# NORTHEAST UTILITIES

Millstone Nuclear Power Station, Unit No. 3  
Technical Review Meeting Summary  
Structural Confirmatory Items

Millstone Nuclear Power Station, Unit No. 3  
SGEB Technical Review Meeting  
June 15, 1984

RESPONSES TO NRC STRUCTURAL AUDIT

FIG. 1

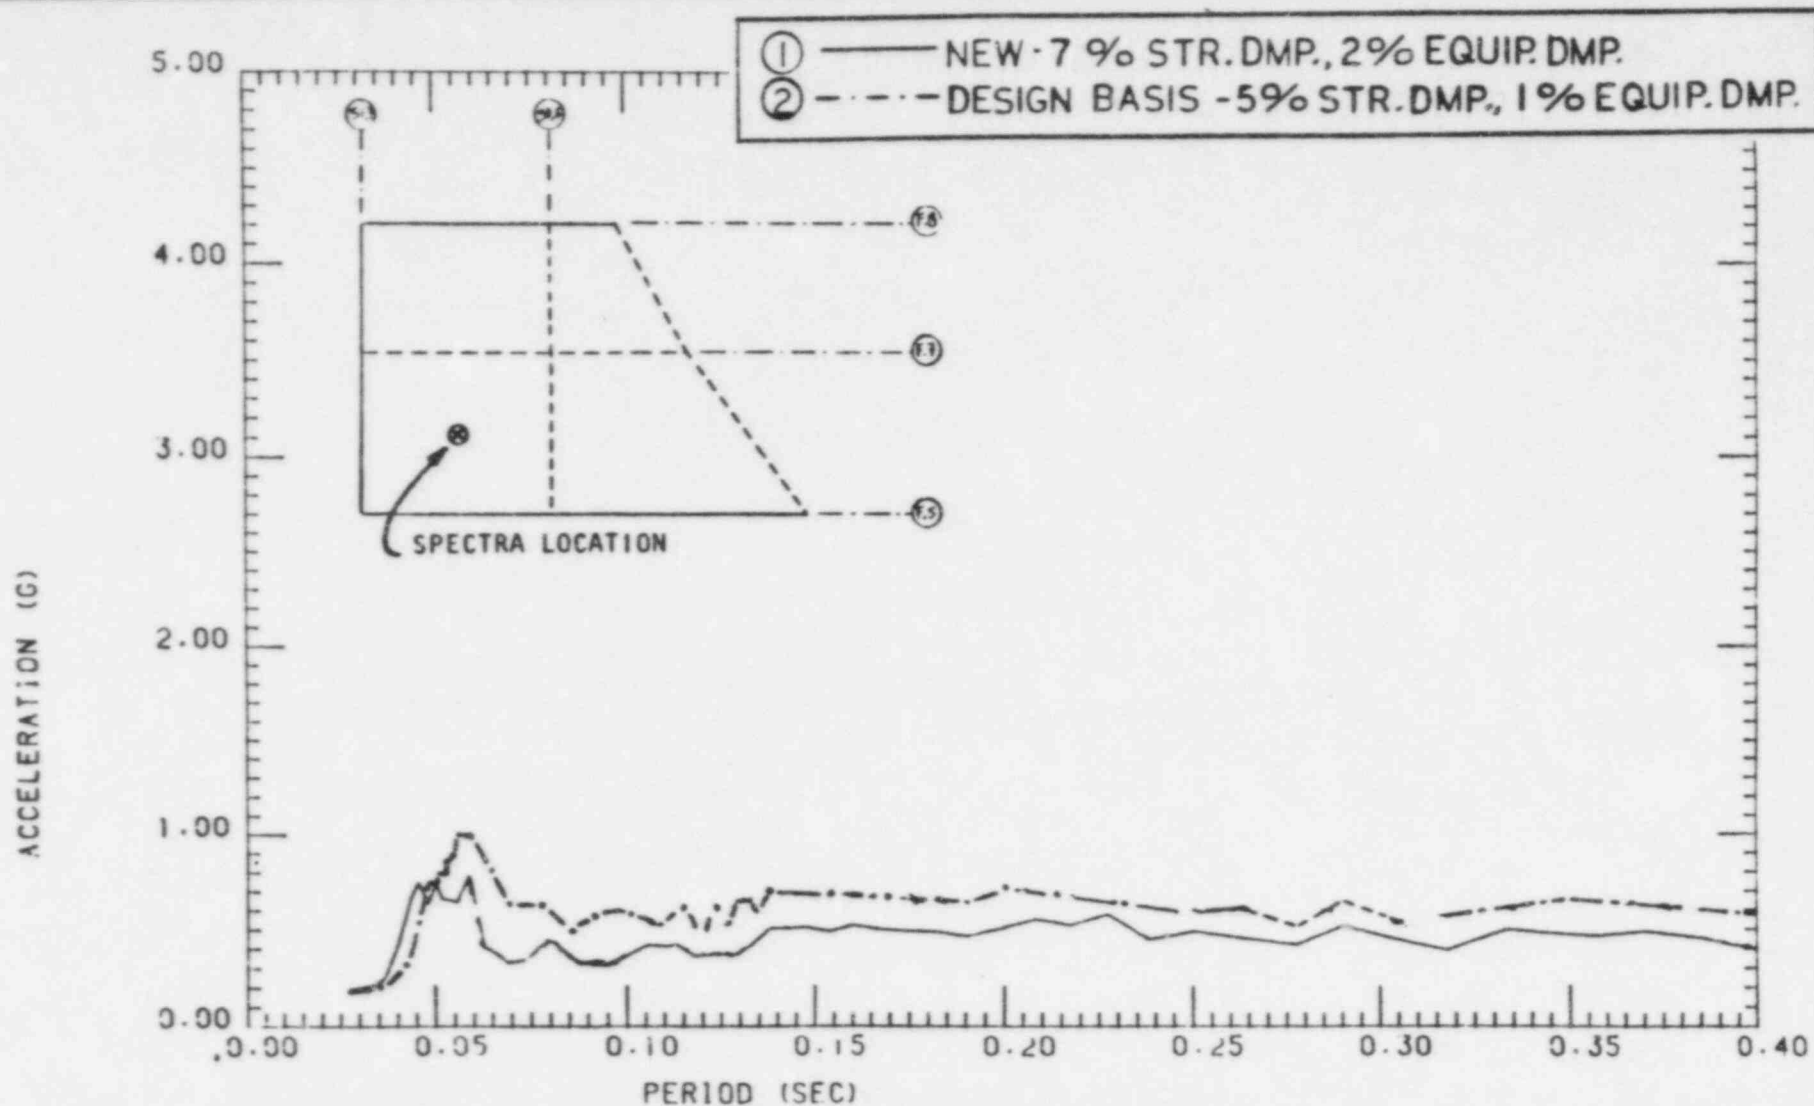
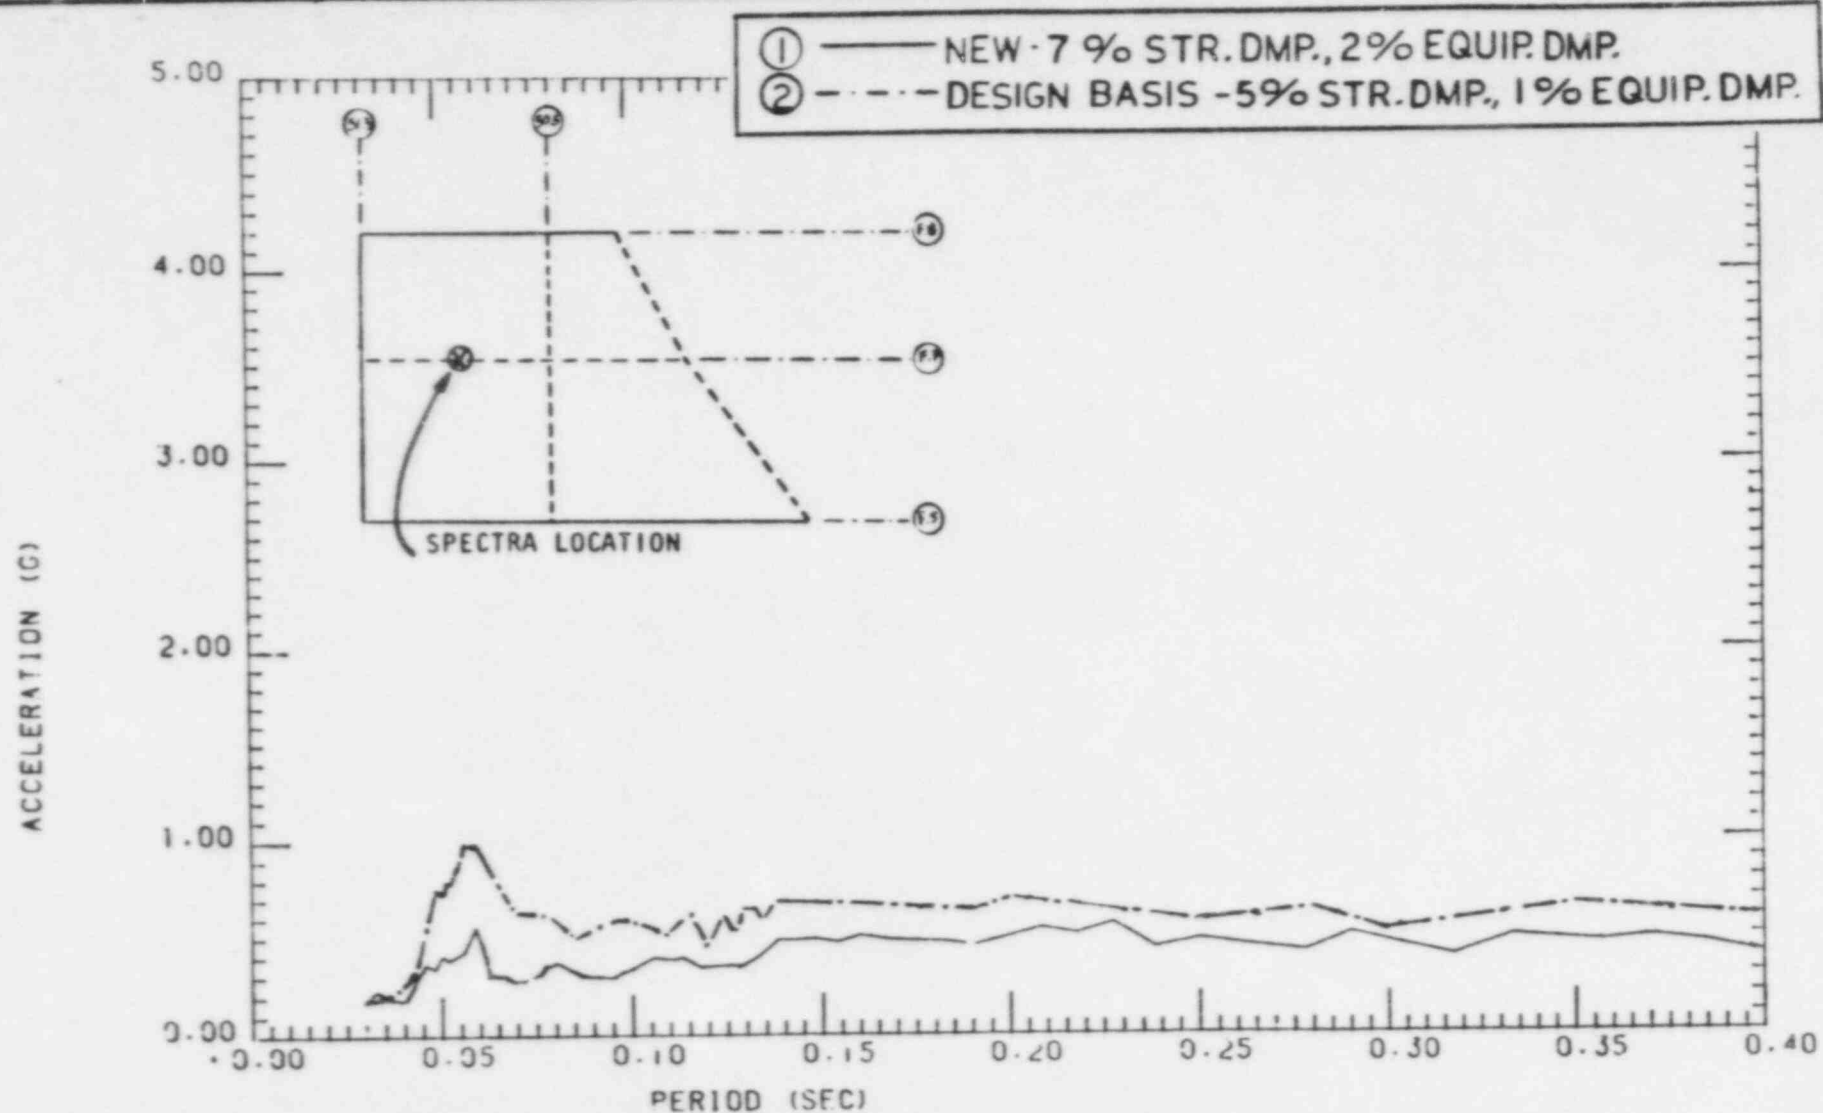
Item 17 - Provide justification as to why vertical flexibility of floor slabs is not considered in generation of floor response spectra.

spectra at structural nodes supporting the slabs were computed, and <sup>This was then</sup> was input into a detailed finite element model of the one-foot thick slabs and spectra were generated at various points. The new ARS generated were compared to the original computed design ARS to determine the amount of conservatism in them. As shown in Figures 1 and 2, the design basis ARS is conservatively bounding except for some minor exceedances.

FIG. 1

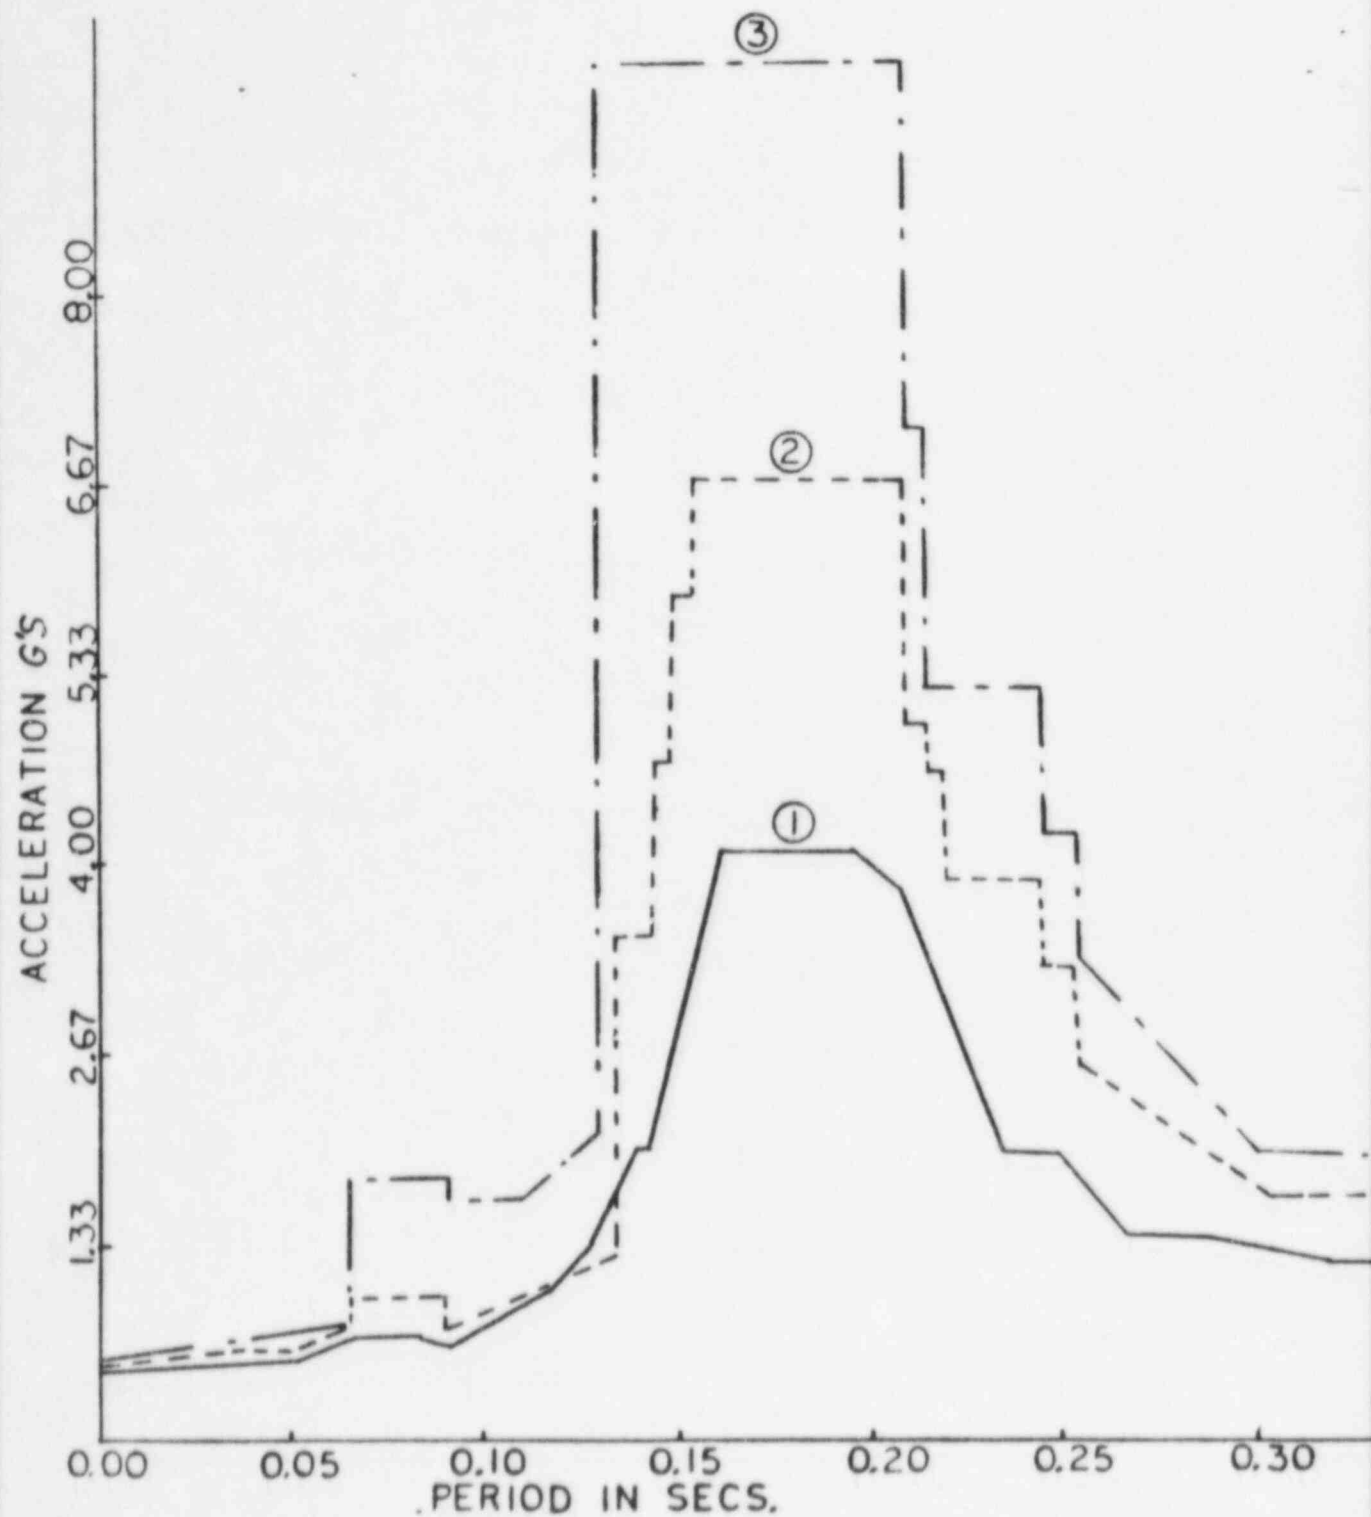
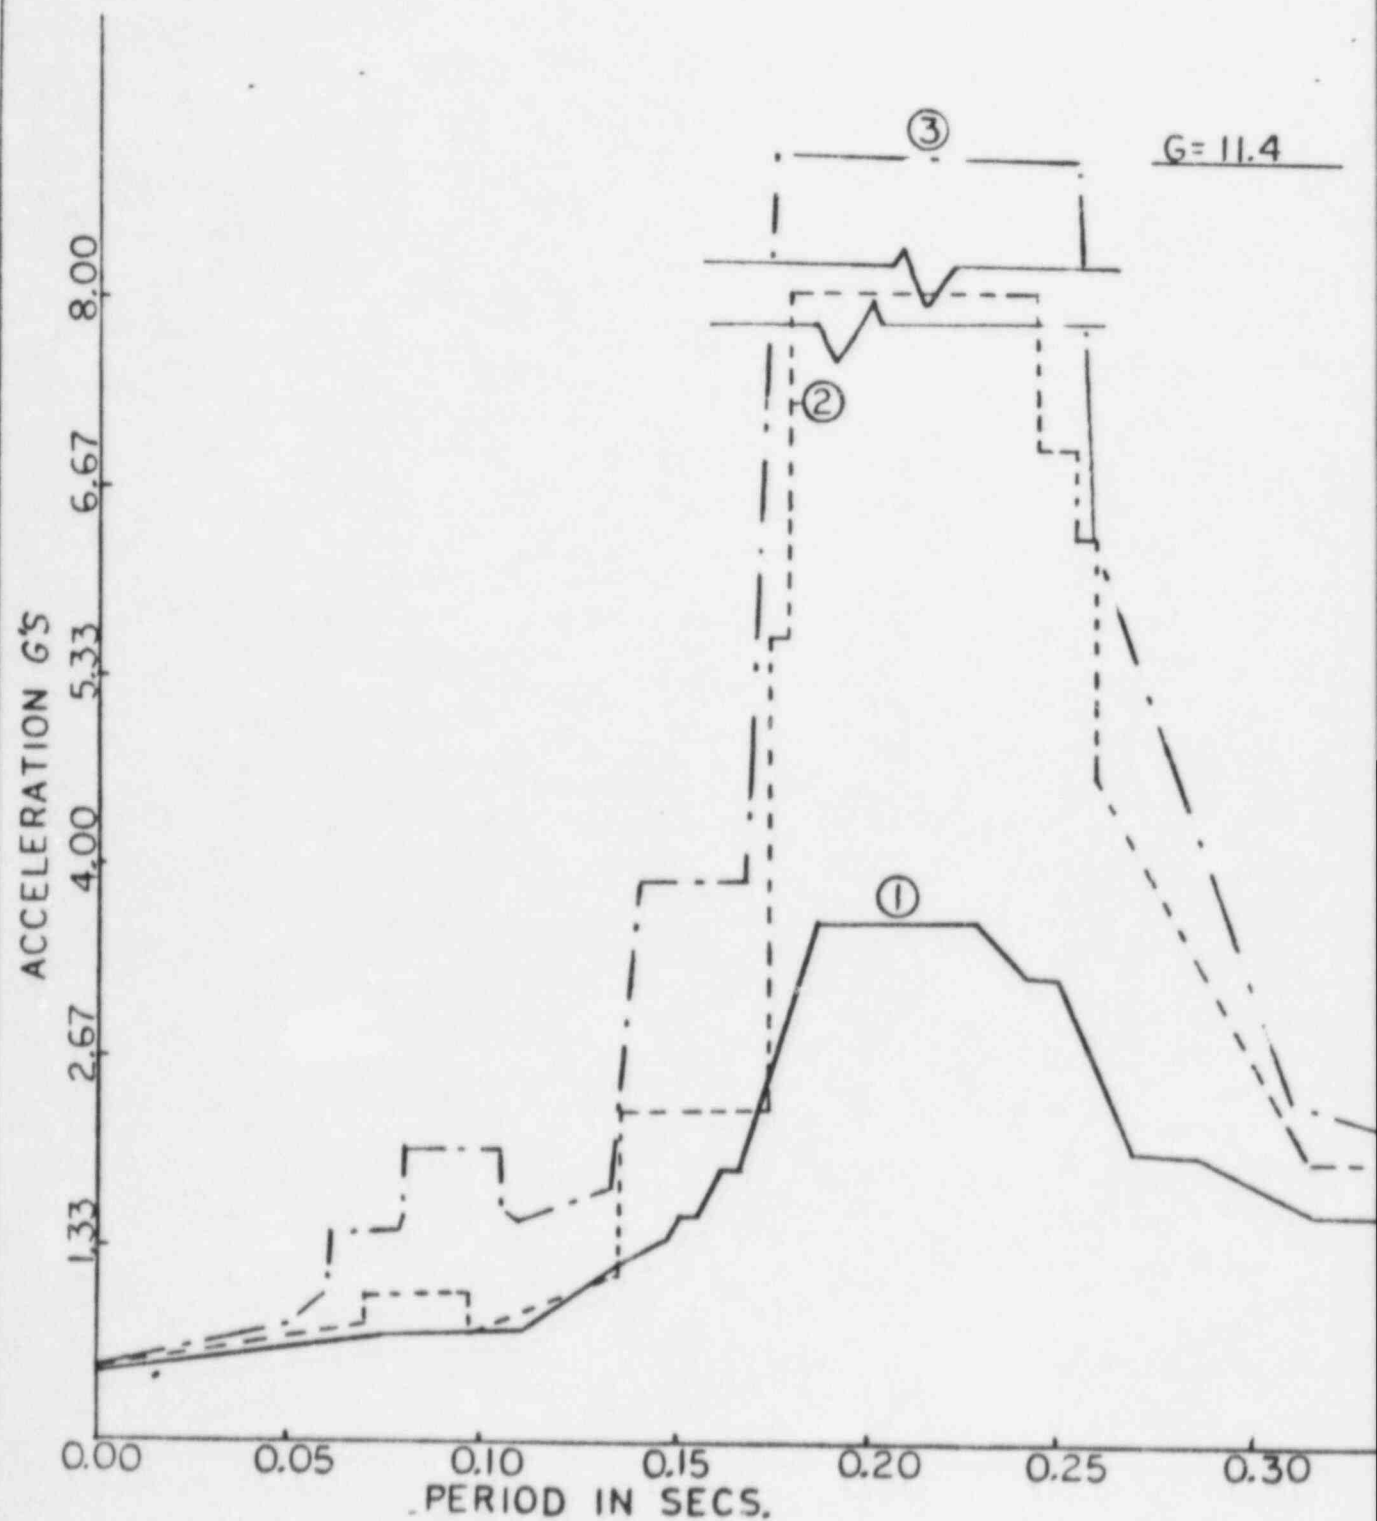
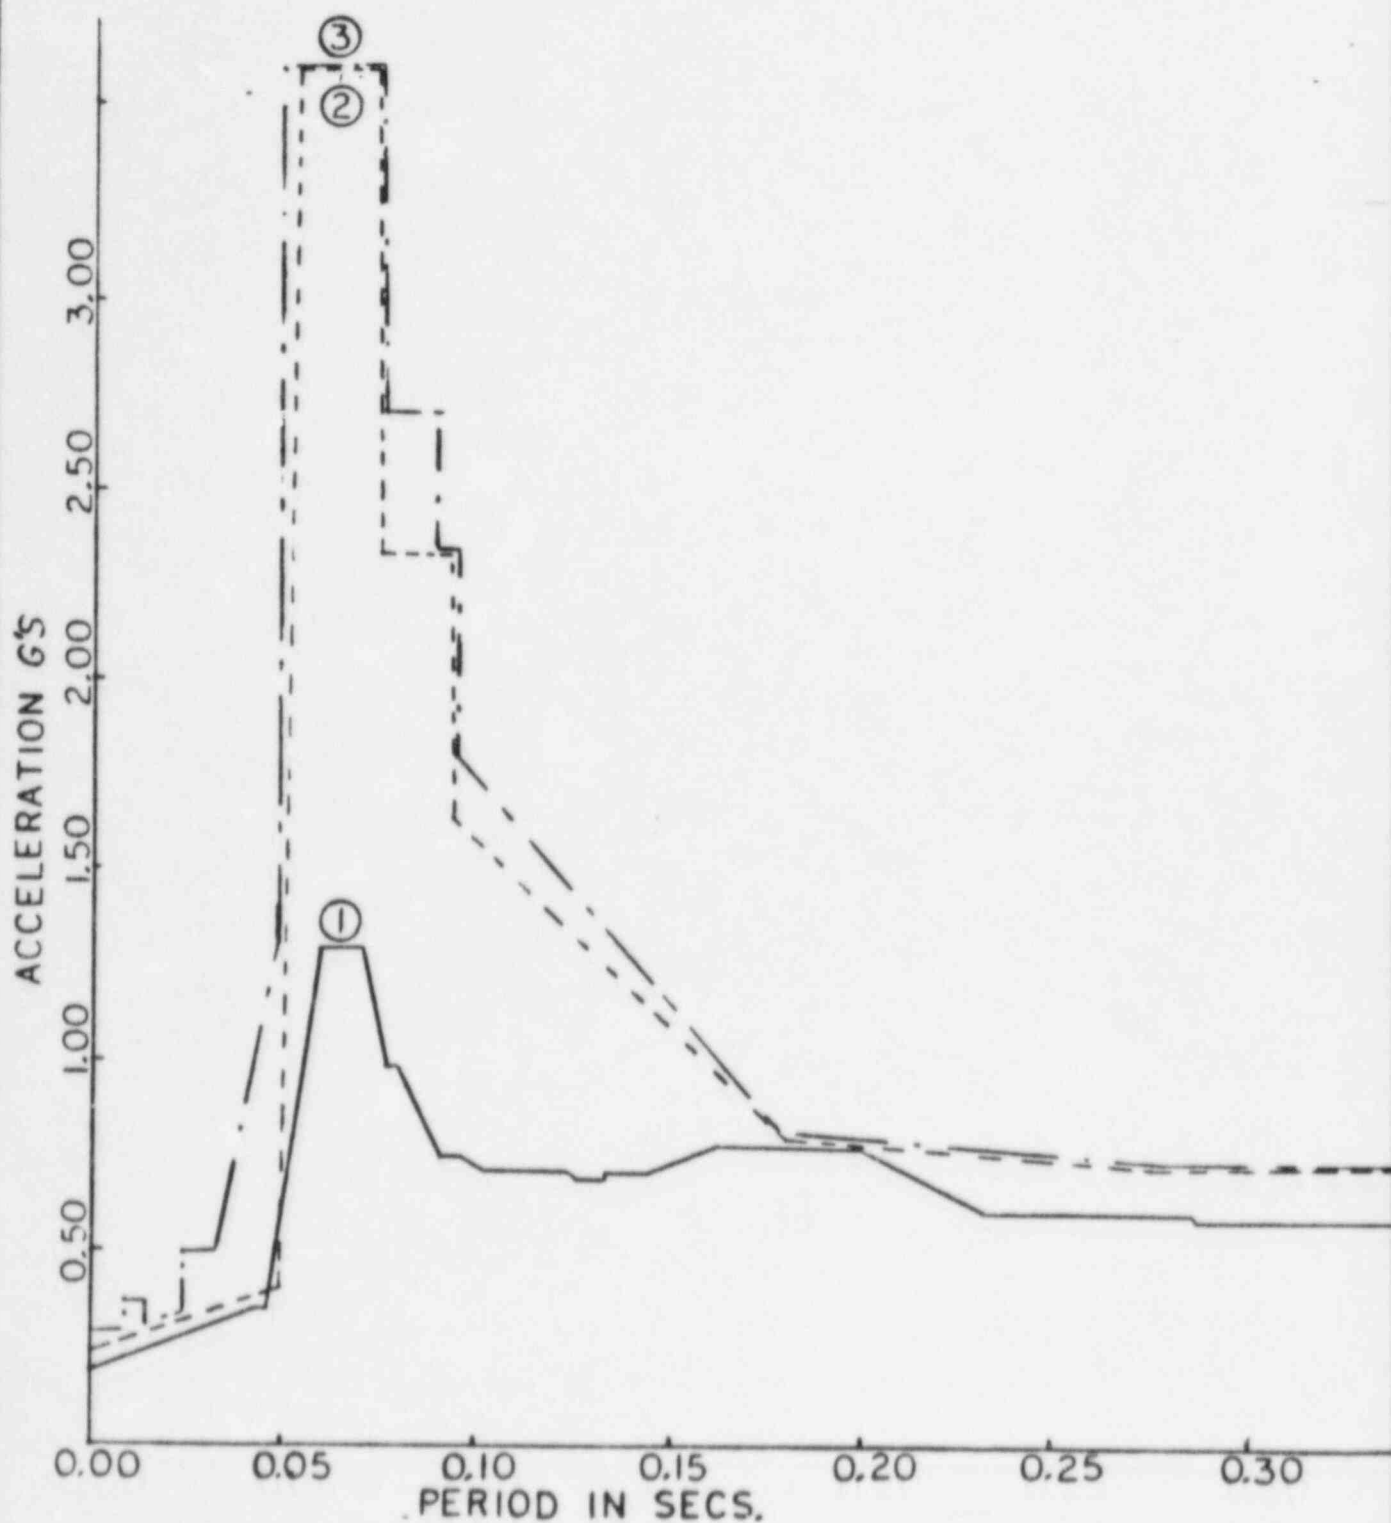
Item 38 - Justify the Peak Broadening Procedure in Relation to Reg. Guide 1.122.

Figures 1 through 3 also contain an additional curve.

- 3) Envelope of ARS generated at 5% structural damping and 1% equipment damping peak broadened according to Millstone 3 criteria. This is an example of the curves used for systems supported at multiple locations in one or more buildings such as piping systems. This ARS curve is taken as the upper bound envelope of all the individual response spectra for these locations.

A review of Figures 1 thru 15 shows that in all but a few isolated cases the original design spectra is bounded by the sensitivity study spectra which employs Reg. Guide 1.122 and Reg Guide 1.61 section criteria. The effects of these exceedances will be discussed in the following criteria.
